UN Regulation No. 135 (Pole Side Impact (PSI))

Proposal for Supplement 3 to the 01 series of amendments to UN Regulation No. 135 (Pole Side Impact (PSI))

Submitted by the experts from Germany *

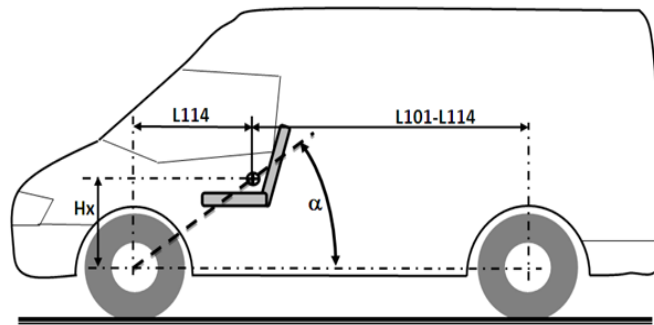
- (a) Category M₁ vehicles with a gross vehicle mass of up to 3,500 kg; and
- (b) Category N₁ vehicles where, **when positioned on a level surface with all tyres inflated as recommended by the vehicle manufacturer and loaded to the unladen vehicle mass as defined in paragraph 2.24.**, the acute angle alpha (α), measured, between a horizontal plane passing through the centre of the front axle and an angular transverse plane passing through the centre of the front axle and the R-point of the driver's seat, as illustrated below, is less than 22.0 degrees; or the ratio between the distance from the driver's R-point to the centre of the rear axle (L101-L114) and the centre of the front axle and the driver's R-point (L114) is less than 1.30.²
